STAFF REPORT 7/24/2019 MEETING
APPLICATION NUMBER 19-6357
ADDRESS: 2458 BRUSH
HISTORIC DISTRICT: BRUSH PARK
APPLICANT: MONA ROSS-GARDNER

PROPOSAL

EAST FACING SIDE OF BUILDING

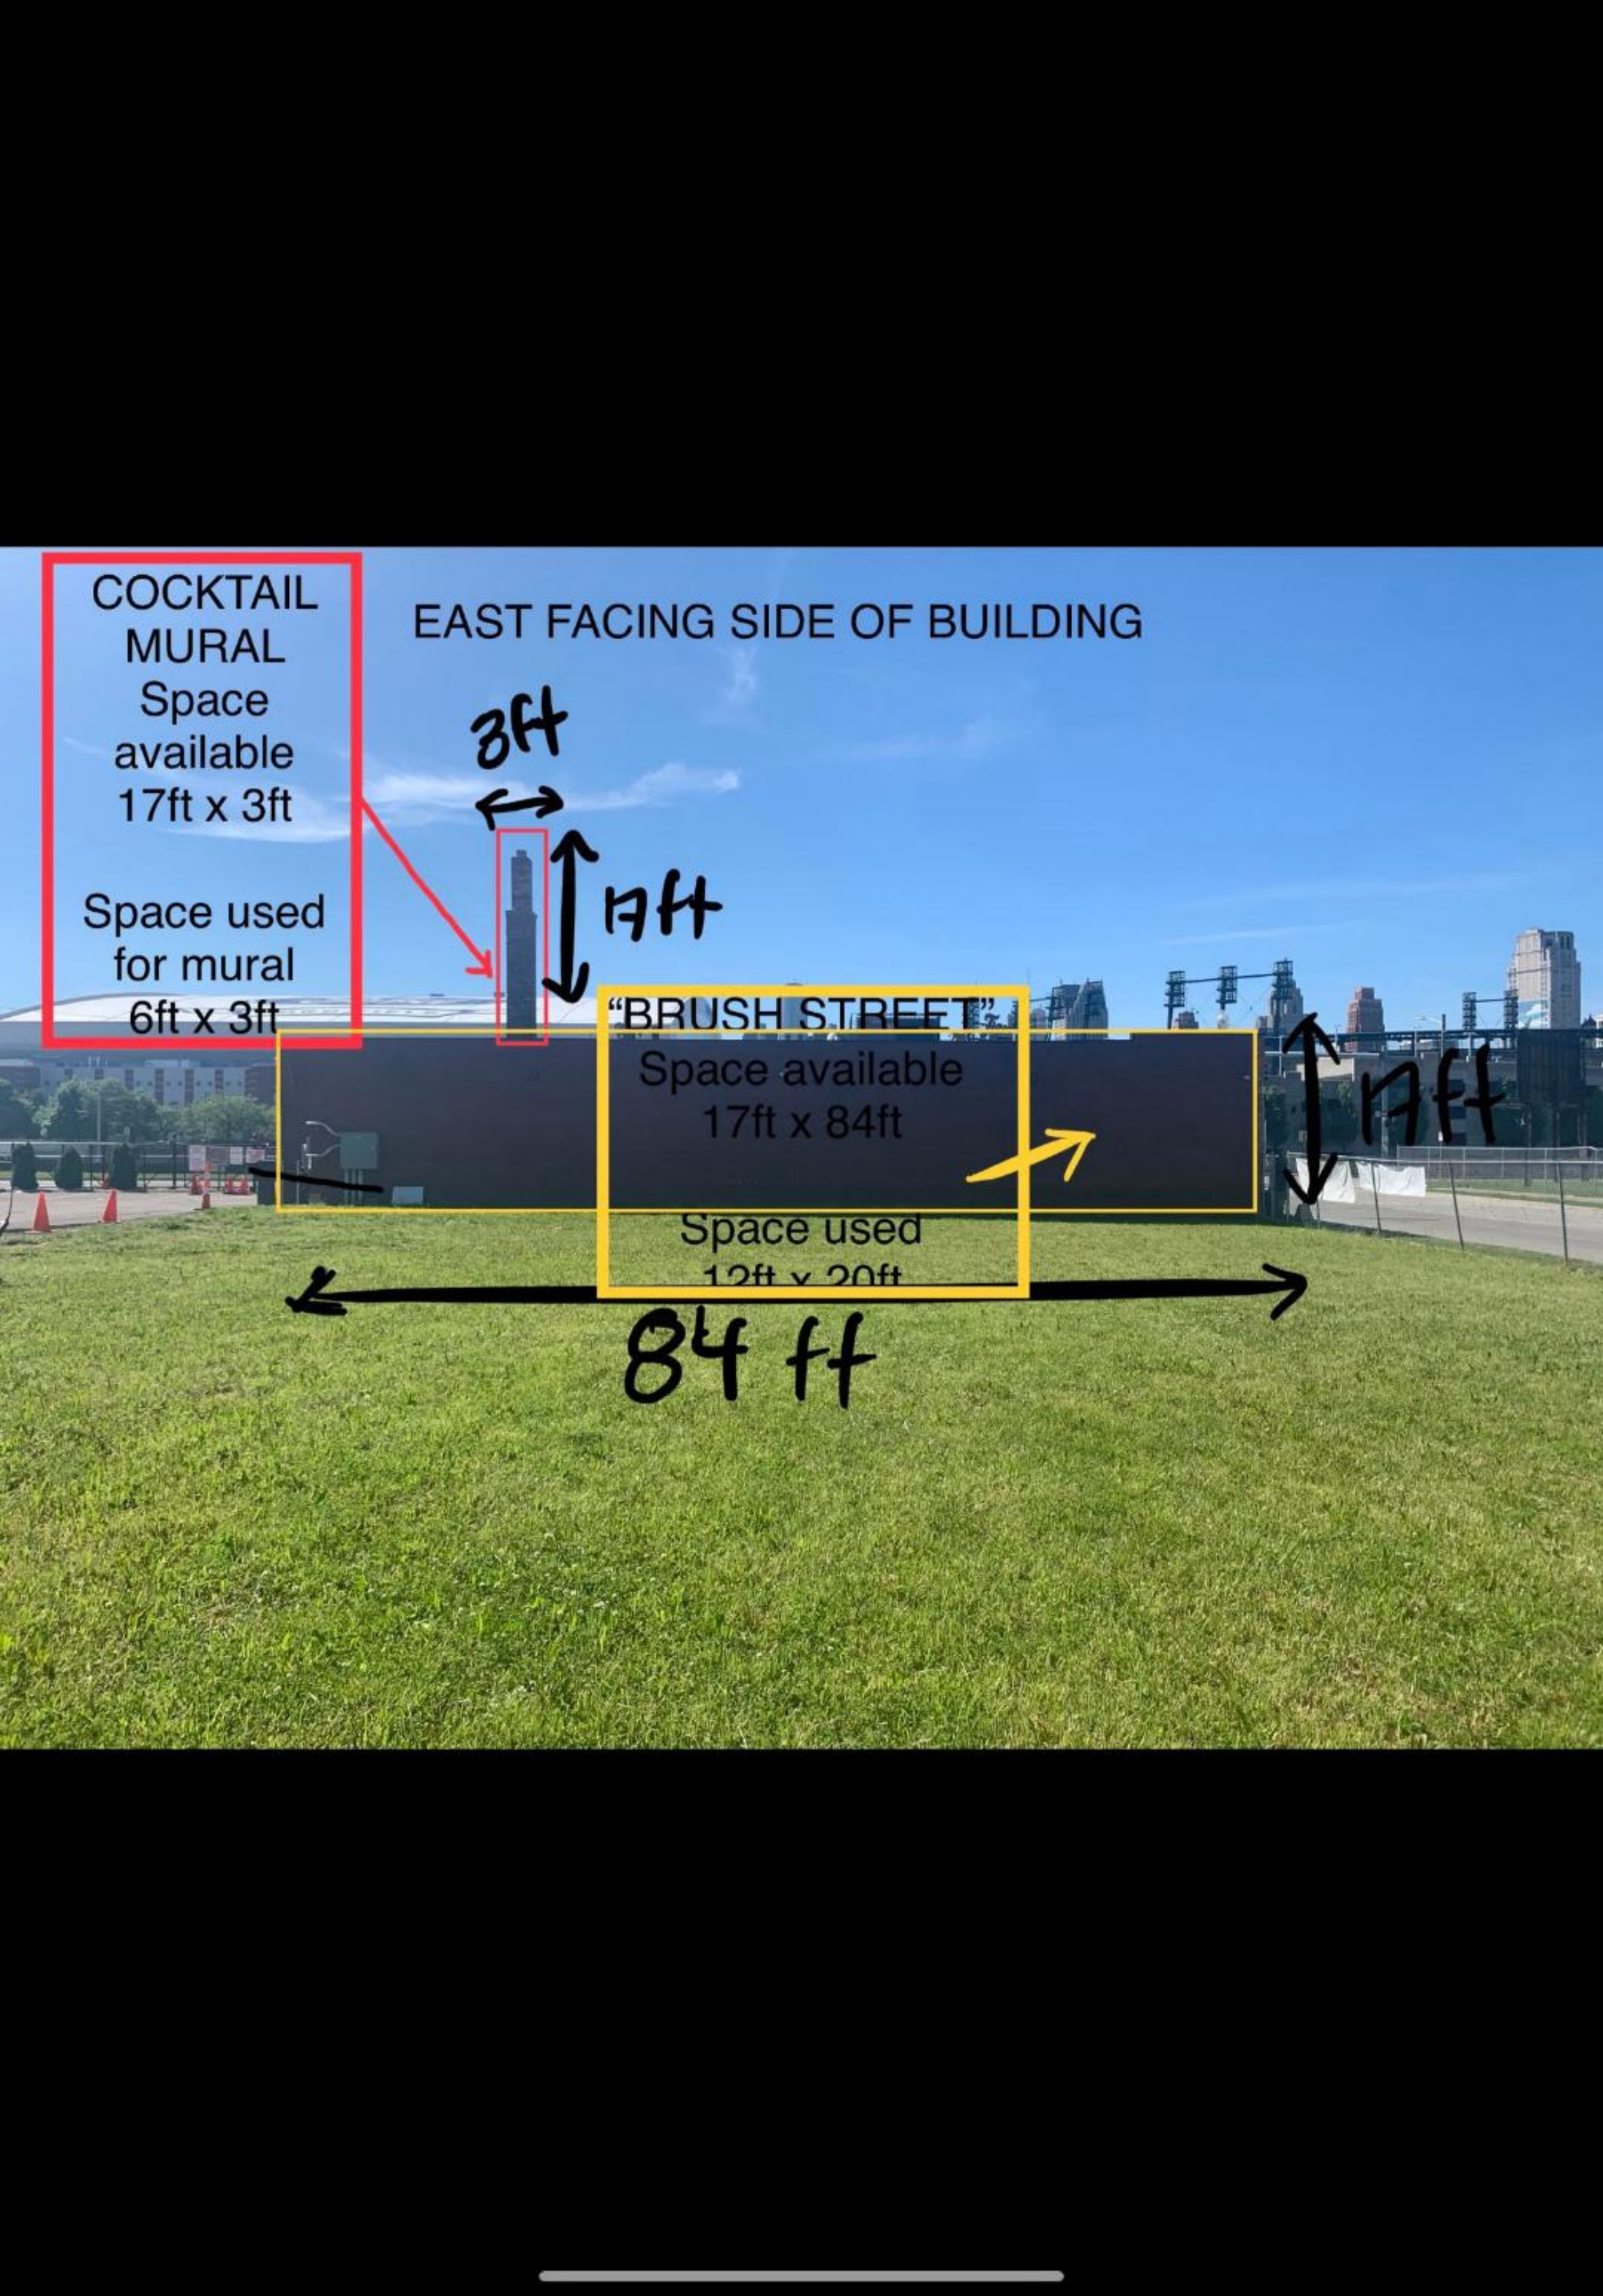
It is the HDC staff's recommendation that the Commission approve the issuance of a Certificate of Appropriateness for the project because it meets the Secretary of the Interior's Standard for Rehabilitation Standard Number 9) *New additions, exterior alterations, or related new construction shall not destroy historic materials that characterize the property. The new work shall be differentiated from the old and shall be compatible with the massing, size, scale, and architectural features to protect the historic integrity of the property and its environment.* However, staff does recommend that the Commission issue this approval with the following condition:

- The new painted signage and murals be confined to the painted portion of the building and the non-historic dumpster enclosure walls
